River Wall Liaison Summary Note

Stag Brewery

Client Name: Reselton Properties

Document Reference: WIE15582-106-BN-1-2-1-EA

SECTION D D - FUTURE

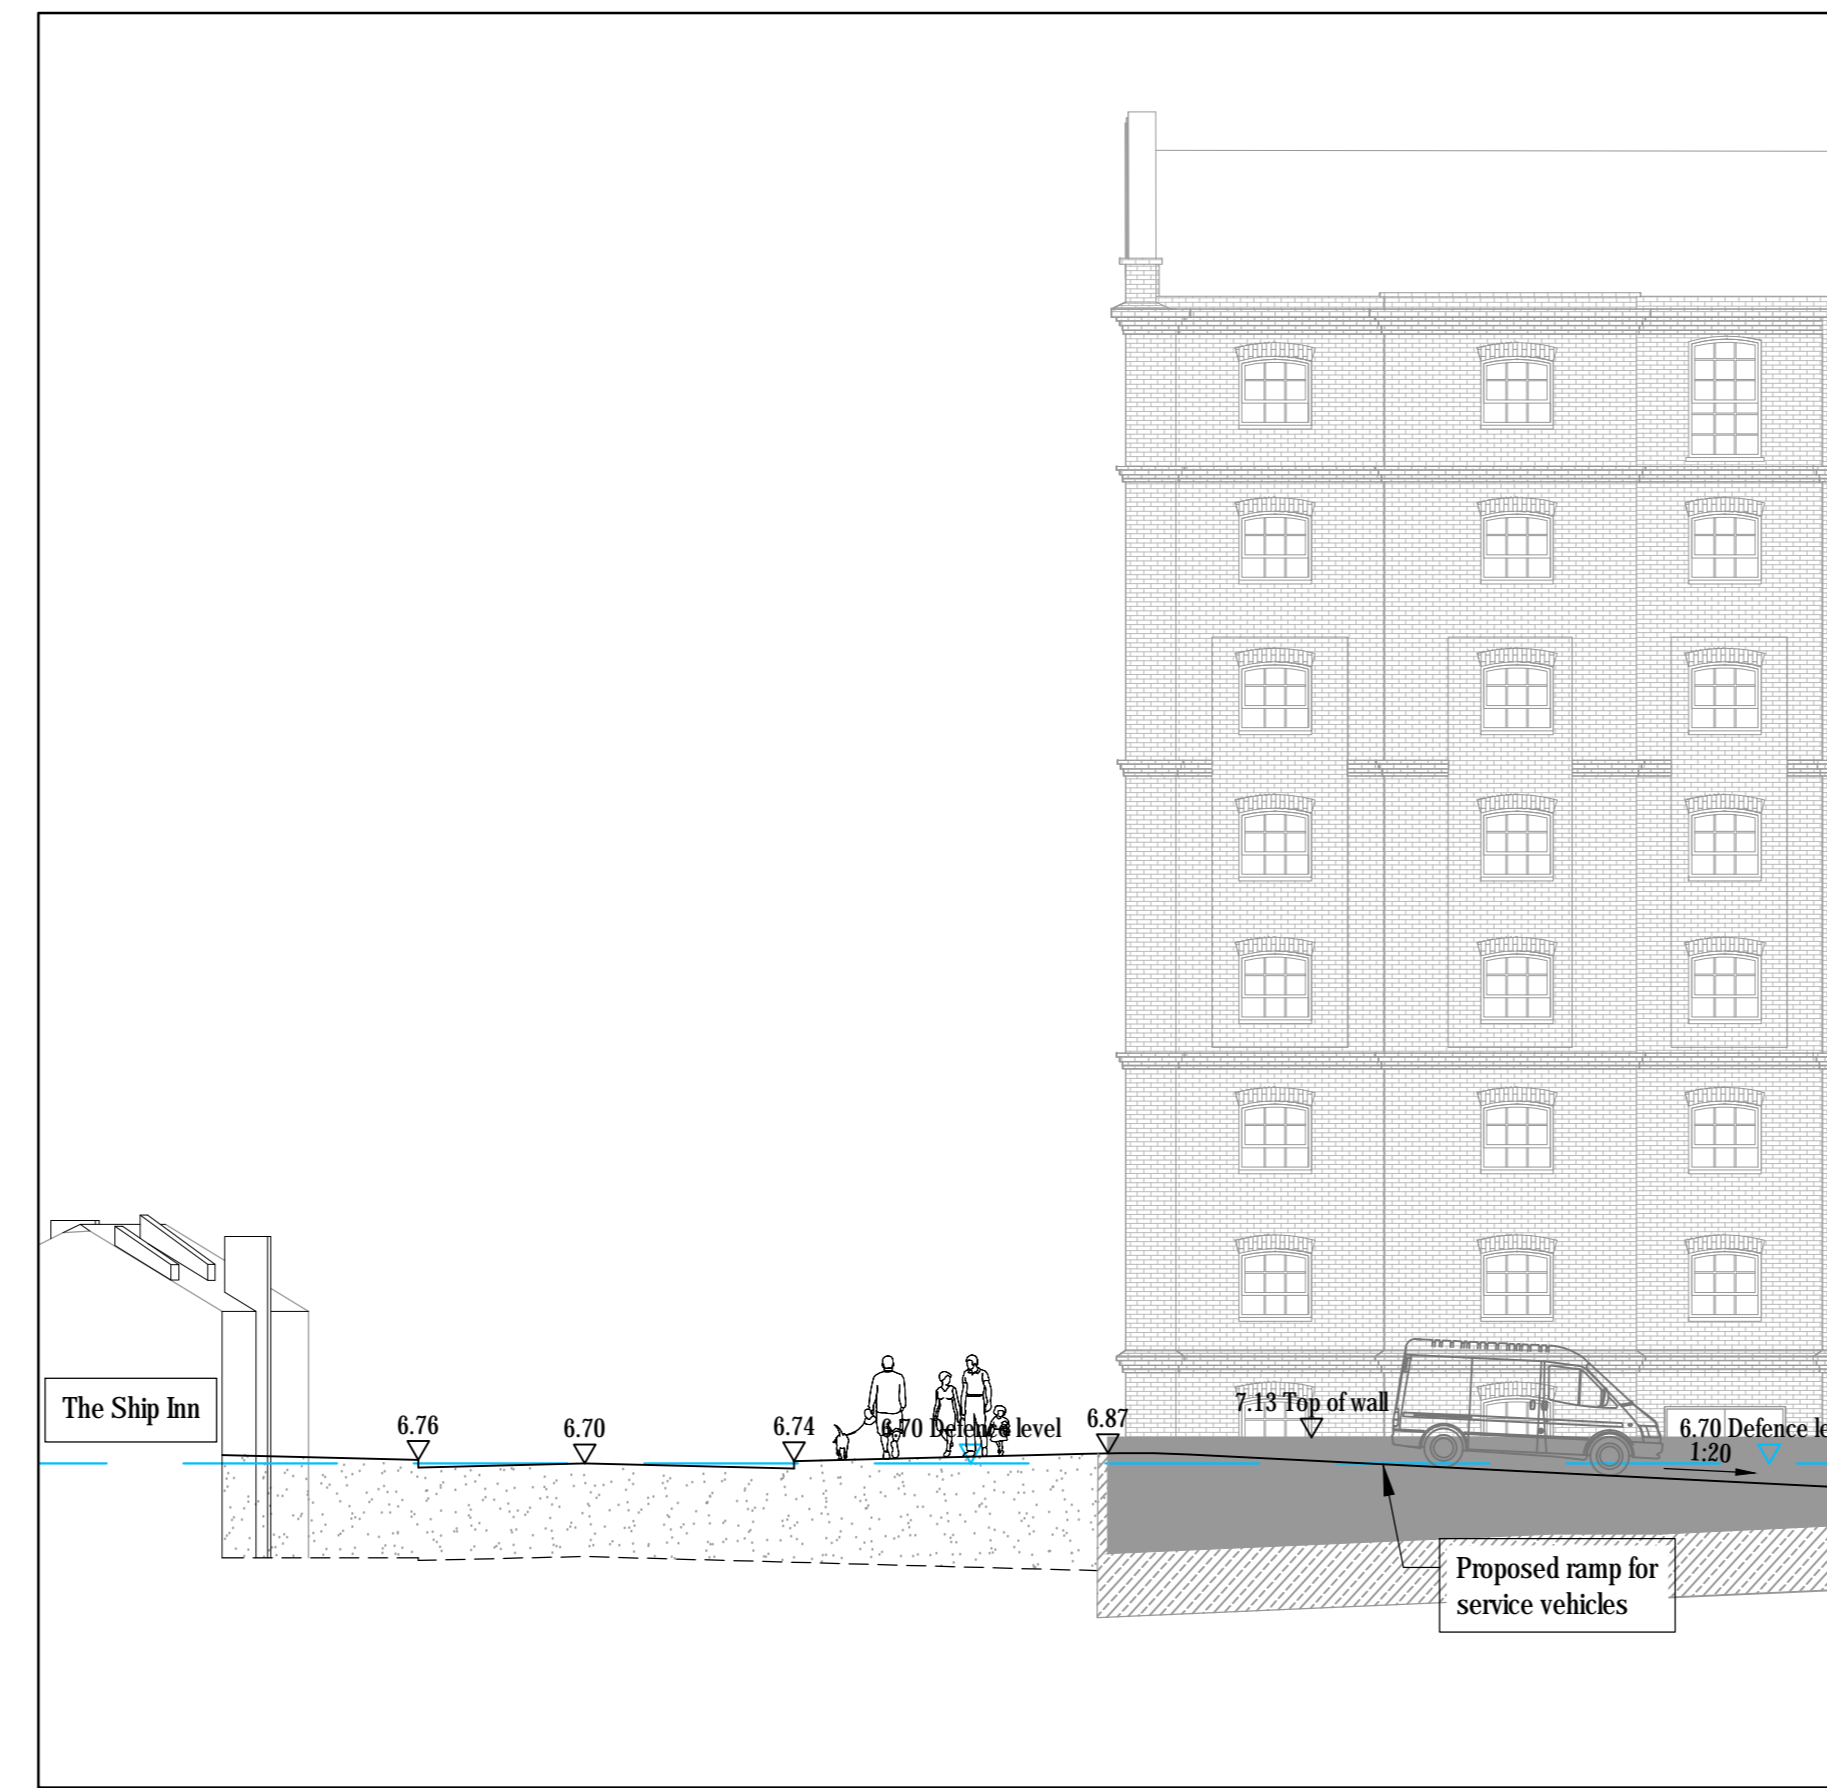
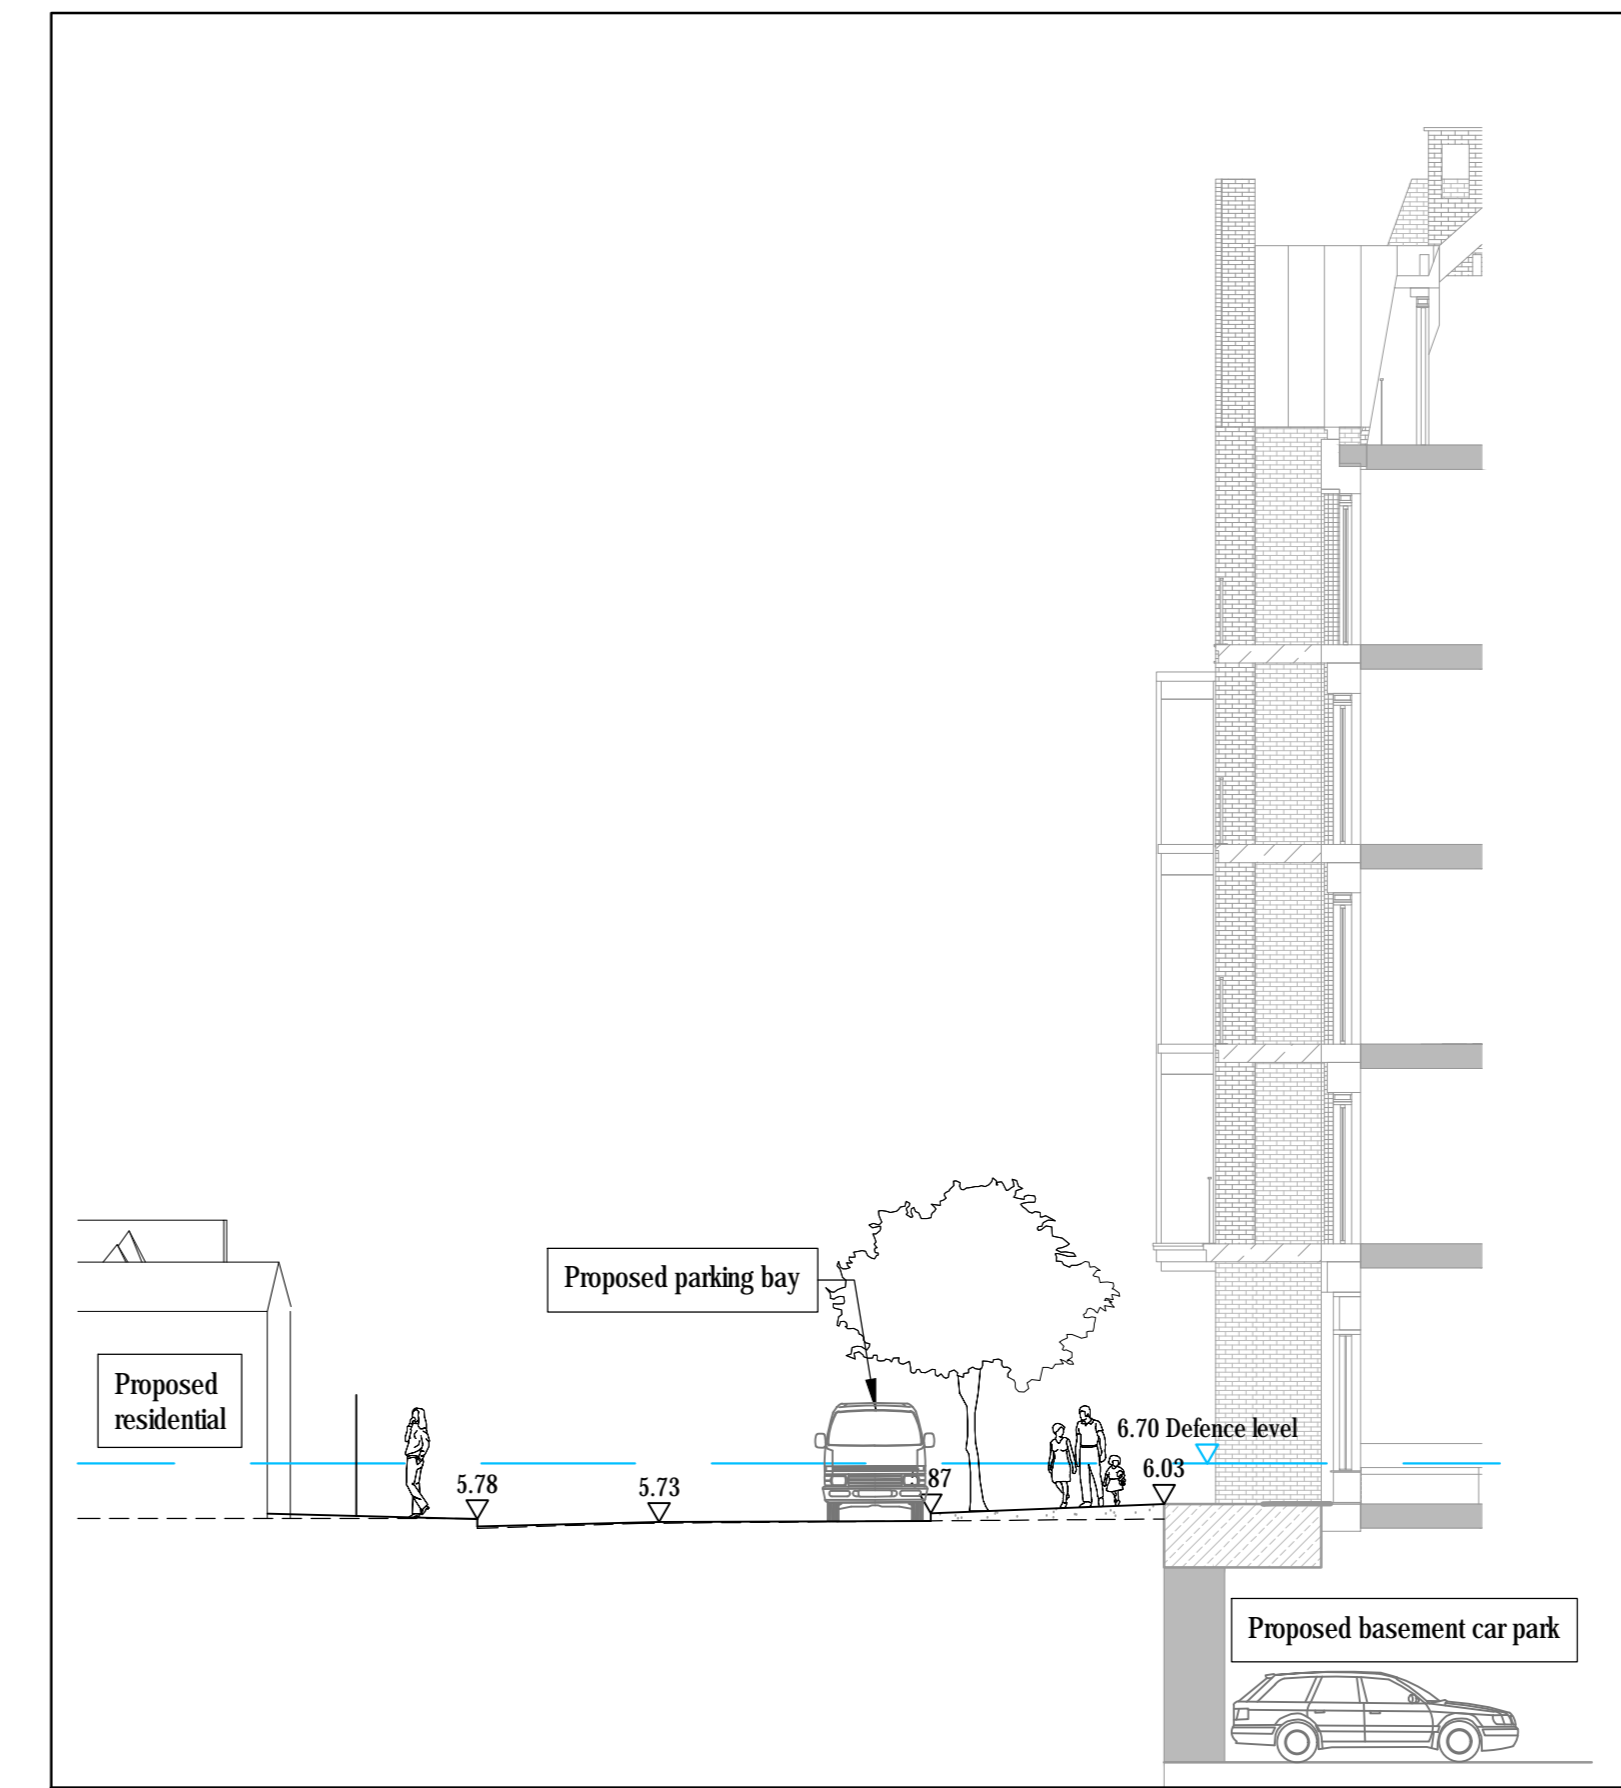
Regarding Ship Lane, we appreciate the applicant may not be the freeholder of this land, and therefore may not be liable to ultimately provide the flood defence across the road. However, the applicant is responsible for demonstrating how all flood defence line within their redline boundary, will be treated in light of TE2100 raising requirements and how these will tie in with the defences on adjacent properties. Developments should not preclude or limit future defence raising options nor should they increase flood risk to neighbouring properties.

- 2.1. As requested by the EA, the team has investigated how a permanent passive flood defence could be incorporated into Ship Lane. As a result, we confirm that in the future it would be possible to raise ground levels on Ship Lane to 6.70m AOD in line with the future requirements of the TE2100 Plan. Drawings provided in Appendix E show how the required ramping would be at a maximum of a 1 in 12 gradient and would not be inhibited by the proposed development (i.e. access would remain achievable with the development in place).

GREEN HATCHED AREA ALL RAISED TO 6.7m AOD, BUT VOID AREA BENEATH FOR STORAGE

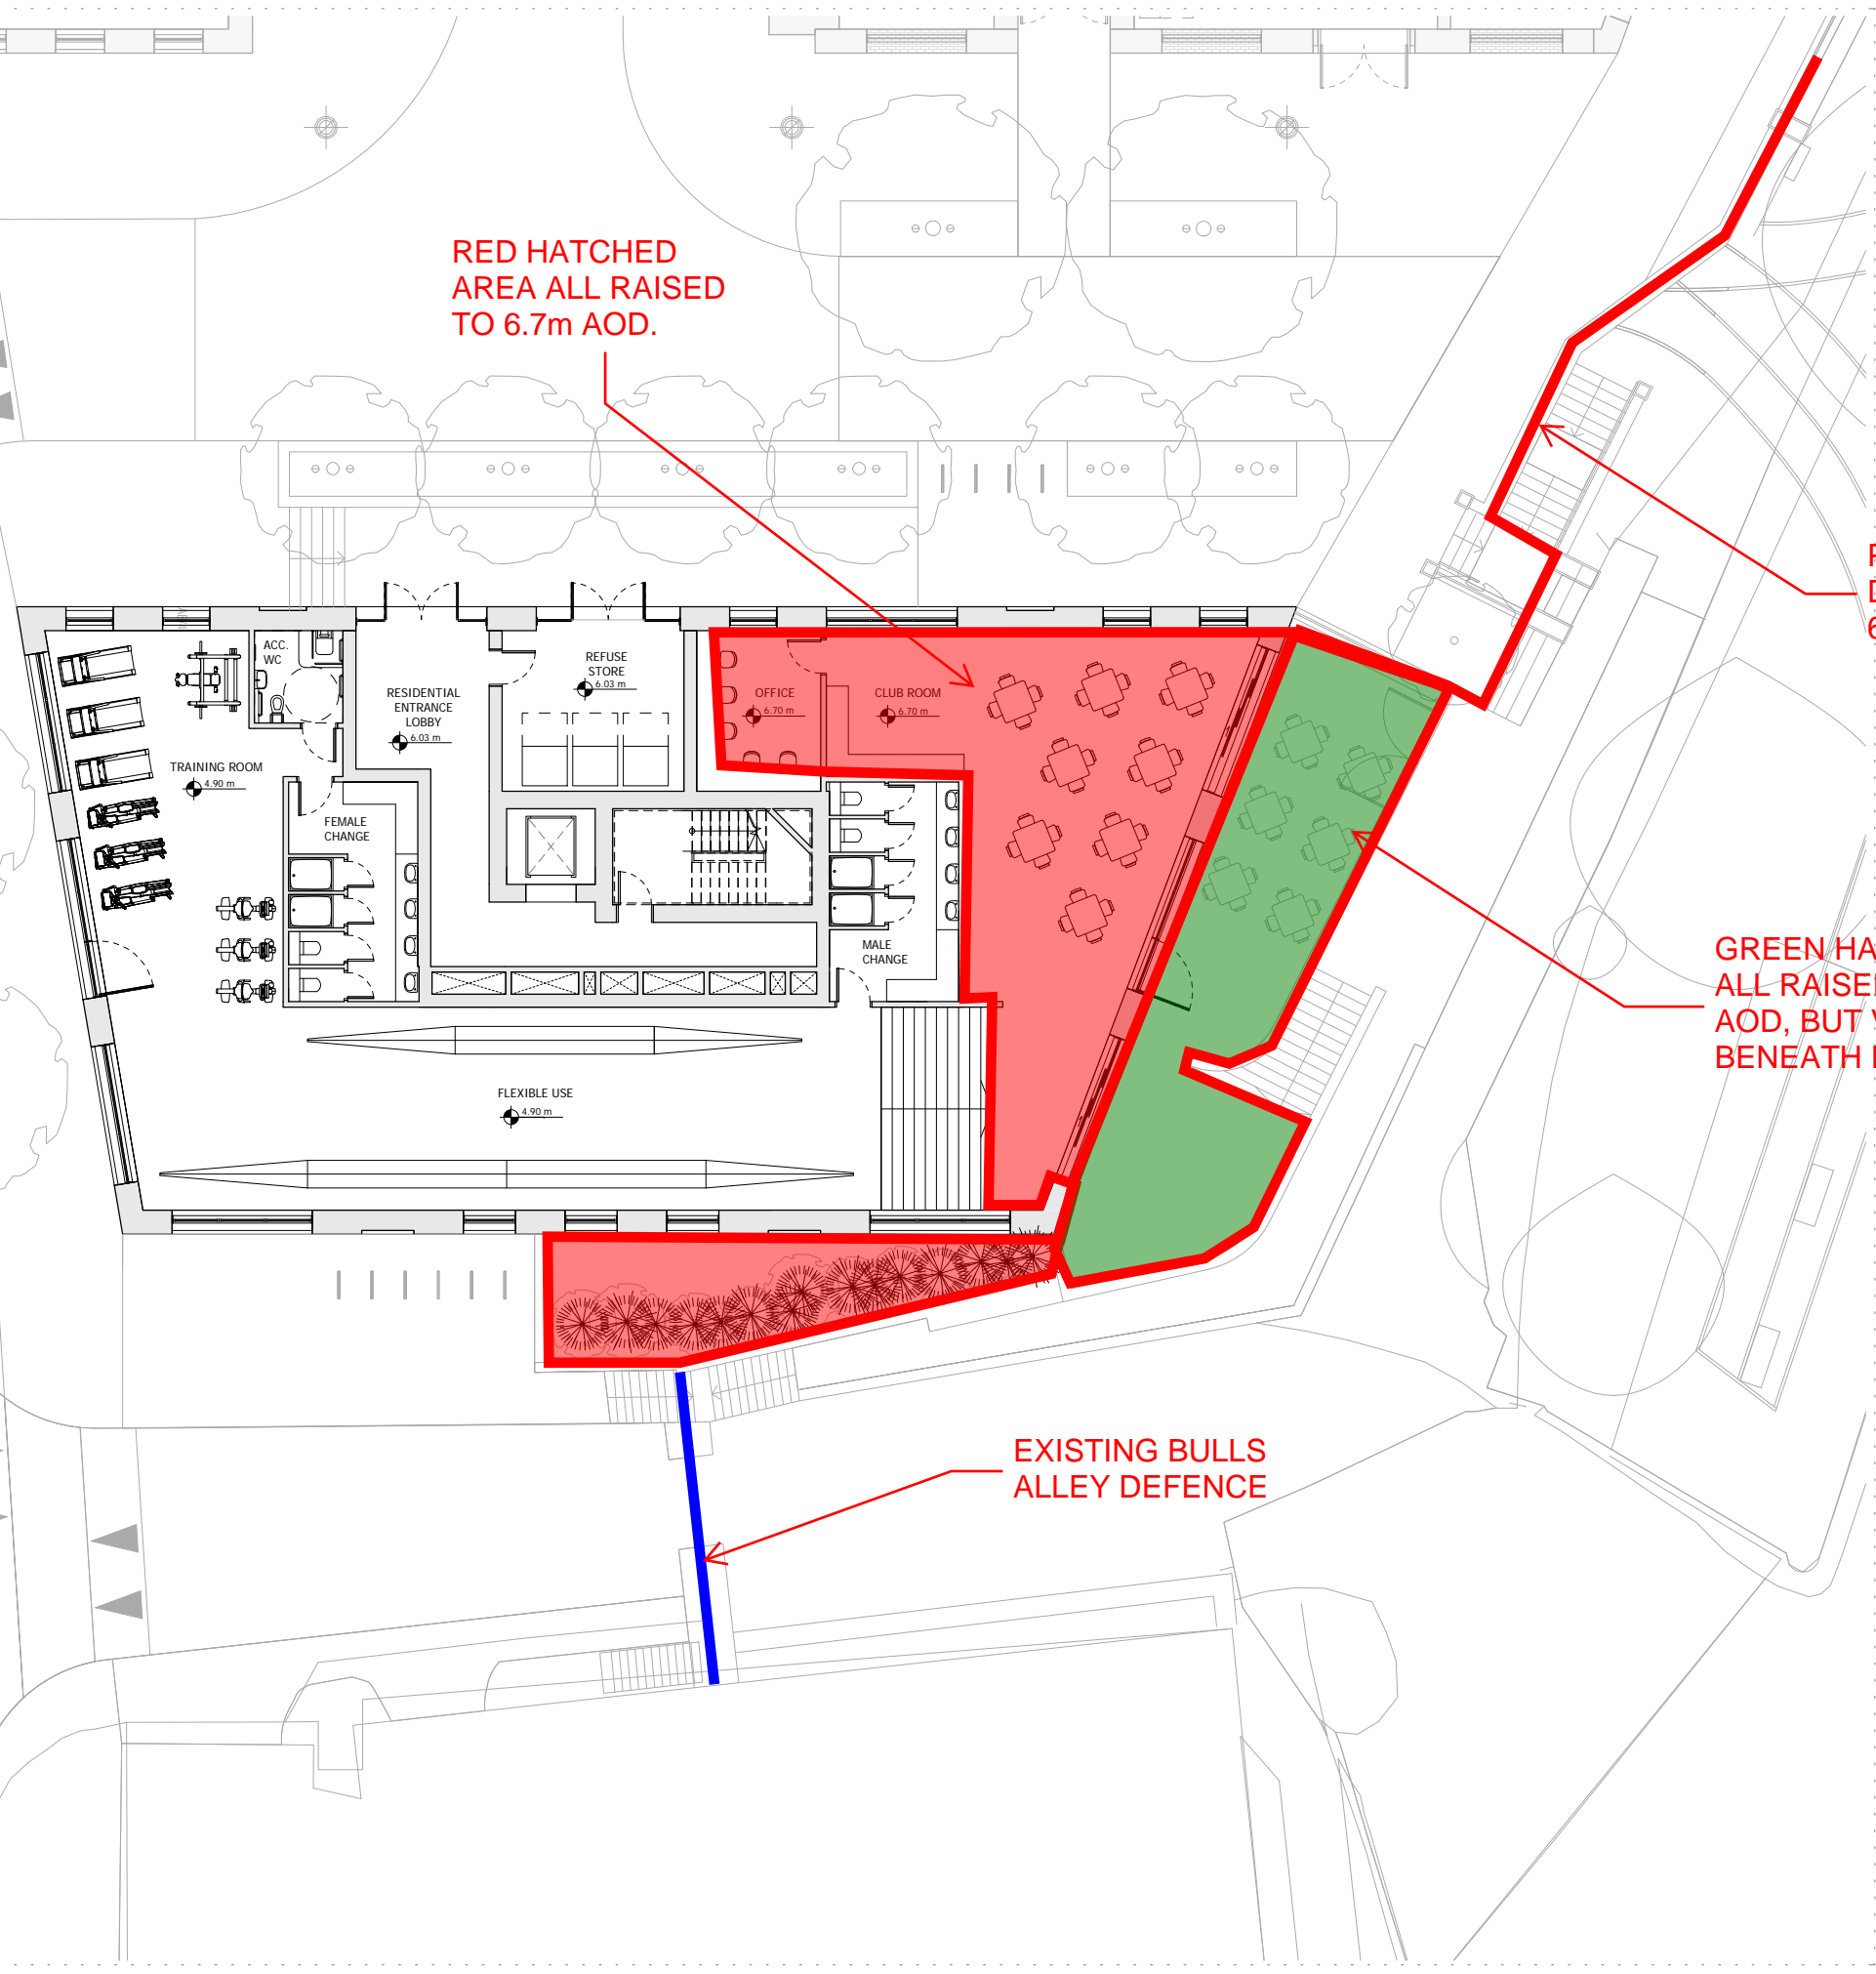
- 4.1. In email correspondence (Appendix B), the EA expressed concerns relating to the confined nature of the boat storage facility beneath the Boat Club terraces. They requested that this would need to be accessible and safe for EA staff when carrying out maintenance and repairs of the flood defence and anyone accessing the space.

The void area for storage is hatched in green on the mark up and is also shown on section drawing G200_B09_E_N_001 which is included in Appendix F (I have attached that appendix on its own for ease of reference).

PROPOSED FLOOD DEFENCE WALL AT 6.7m AOD.
